ITEM 6(c)

Description New residential dwelling (retrospective) and associated works

At Site to the West of 1, London End Lane, Bow Brickhill,

1.0 RECOMMENDATION

As-Built Rear Elevation 1:100

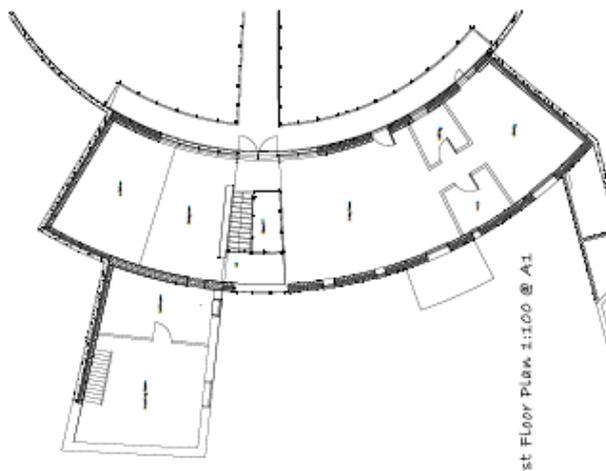
- 2.17 The house as built, whilst a similar size and shape to the approved dwelling, has replaced the approved garage with additional habitable accommodation, replaced the bike/bin store with a larger garage and includes a new, two storey high, 'wing' on the north-western end of the building to provide two stores. The dwelling as built is faced in white render with contrasting grey framed windows that are not recessed and are of a different style and appearance to the approved drawing. A large air conditioning unit has also been fitted to the front of the dwelling.
- 2.18 The current proposal includes a proposal to paint the render on the front elevation with a paint known as 'Warm Ash' which is a soft, sandy-green colour. This has not altered since 7th May DCC.

- 7.16 The use of white painted render on the elevations makes the building stand out against the woodland around it. The new garage and projecting side wing increase the bulk of the building and the amount it projects above the ground rather than sit down into the hill. Plan:MK Policy D5 requires that the design of vehicle parking facilities should ensure that an attractive and coherent street scene is maintained. The changes to the contouring of the site have led to the site appearing as a jarring feature against the surrounding landscape, rather than a feature sculpted into its surroundings. Particularly along the north-eastern boundary where the soil has been piled up to head height immediately abutting the footpath, the site dominates its surroundings. The changes to the access and the erection of the entrance gate pillars have turned what was a low key, lightly engineered entrance into an overpowering and visually intrusive feature. All these changes to the development as approved have had a significant and damaging impact upon the appearance of the area.

As-Built Front Elevation 1:100

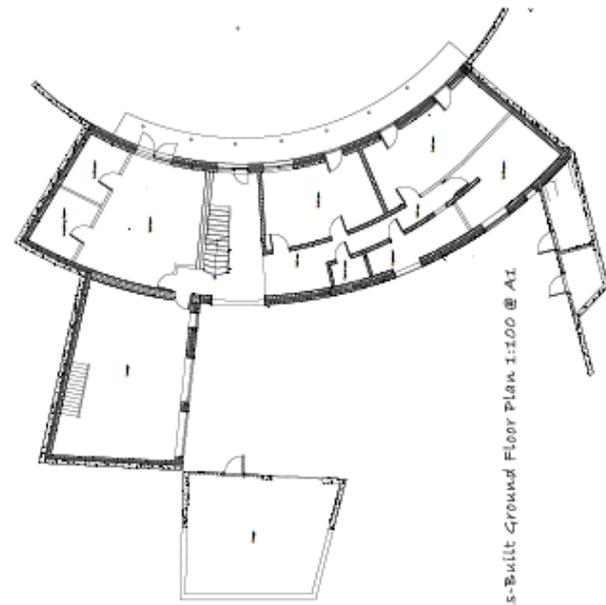
- 2.19 The applicants have submitted drawings showing planting from the 'Green Roof' cascading down, and climbing plants climbing from new beds up a stainless steel trellis over parts of the front elevation.

- 7.20 The applicant has also provided plans showing plants trailing down the front elevation from the existing 'Green Roof' to help break up the hard edge that the roof currently displays. At the time of writing those drawings have not yet been received. An update on the drawings will be provided prior to the Committee meeting.
- 7.21 Plan:MK policy D1 requires development to respond appropriately to the site and the surrounding context and provide appropriate landscaping and boundary treatment to enhance the surrounding area. Policy D2 requires that development should exhibit a positive character and provide visual interest through careful use of detailing. Policy D3 requires that a building's form, massing and façade elements create character and visual interest. As the application stands it is considered that the proposal would be contrary to policies D1, D2 and D3 of Plan:MK.
